V2500-A1/A5/D5 SERIES PROPULSION SYSTEMS SERVICE BULLETIN

This document transmits Revision 2 to Service Bulletin EV2500-72-0365 and the Initial Issue of the Supplement

V2500-ENG-72-0365

ENGINE – PROVIDE PRETRENCHED SECOND STAGE HPT AIR SEALING RING SEGMENTS

Modification of Turbine Case and Vane Assemblies
Figure 1 (Sheet 1)

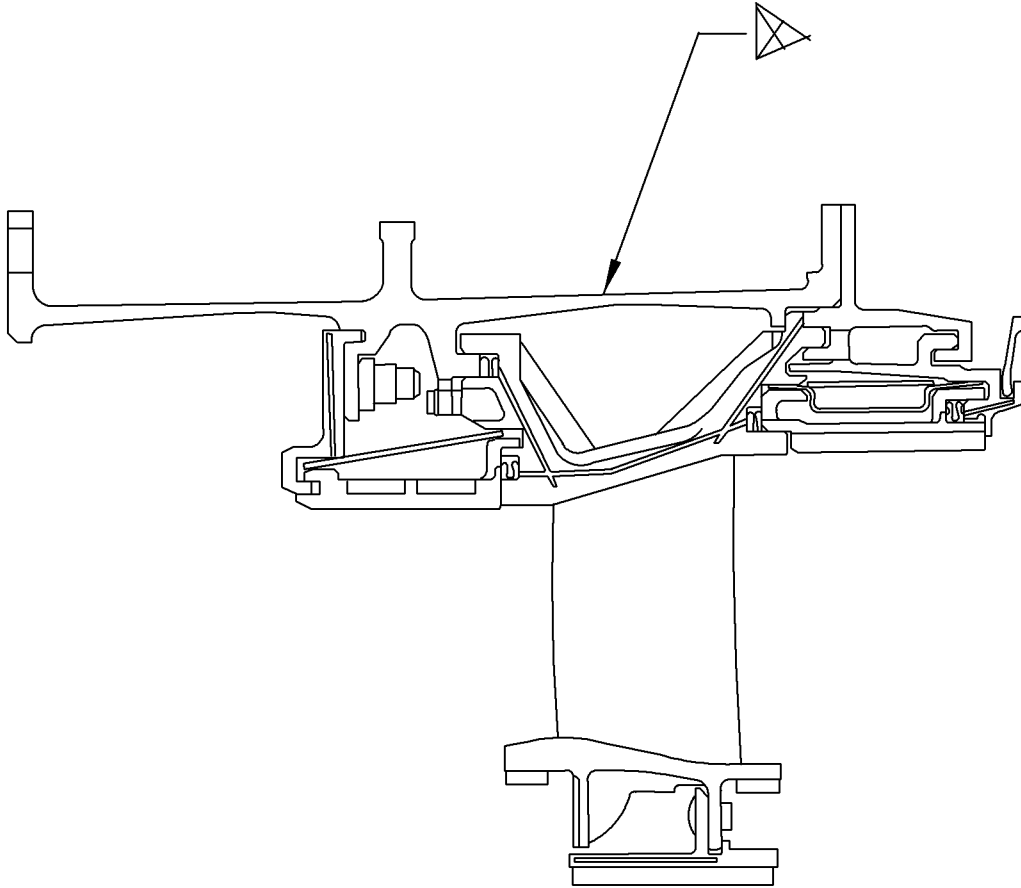
- (1) Follow the procedures as specified in Reference 5. and 6., Chapter/Section 72-45-20, Disassembly, to gain access to the Ring Segment And Vane Cluster, HPT 2 Stage Assemblies.
- (2) Machine the Ring Segment And Vane Cluster, HPT 2 Stage Assemblies, as specified on Figure 1, Sheets 1 and 2.
- (3) Identify the Ring Segment And Vane Cluster, HPT 2 Stage Assembly as shown below and by the procedures as specified in Reference 7., Chapter/Section 70-09-00, marking of parts. See Figure 1 Sheet 1

OLD PART NUMBER	NEW PART NUMBER
2A2272	2A2272-002
2A2372	2A2372-002
2A3172	2A4902
2A3272	2A5002
2A2372	2A3372-001
2A3472	2A3472-001
2A3812	2A5102
2A3822	2A5202

Replace or modify the Stage 2 HPT Air Sealing Ring Segments with new assemblies featuring five pre-machined trenches.

Modification of Turbine Case and Vane Assemblies
Figure 1 (Sheet 2)

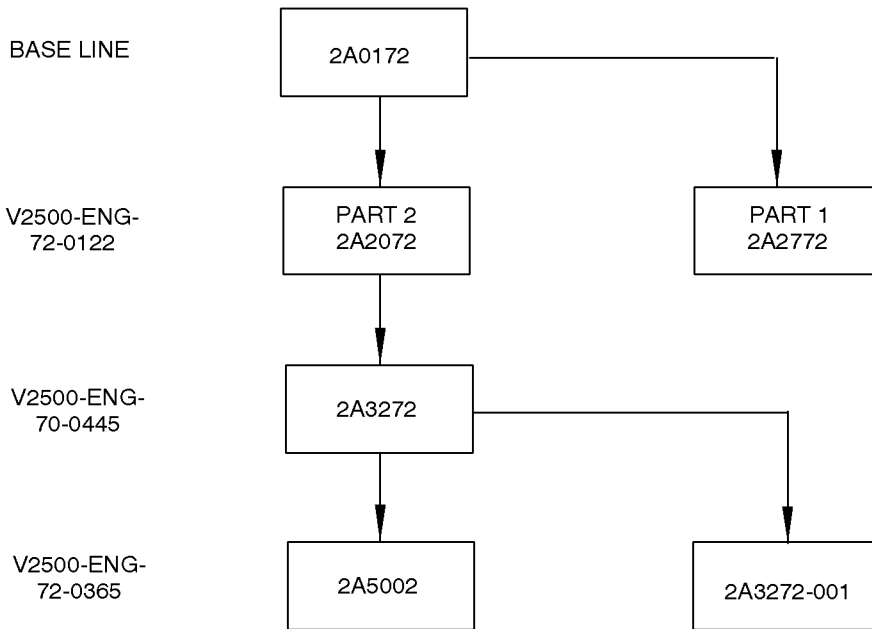
- (4) Assemble the Turbine Case And Vane Assemblies by the procedures as specified in Reference 5. and 6.
- (5) Identify the Turbine Case And Vane Assemblies as shown below by the procedures as specified in Reference 7., Chapter/Section 70-09-00, marking of parts. See Figure 1 Sheet 2

OLD PART NUMBER	NEW PART NUMBER
2A3304	2A3468
2A3364	2A3469
2A2640	2A2640-001
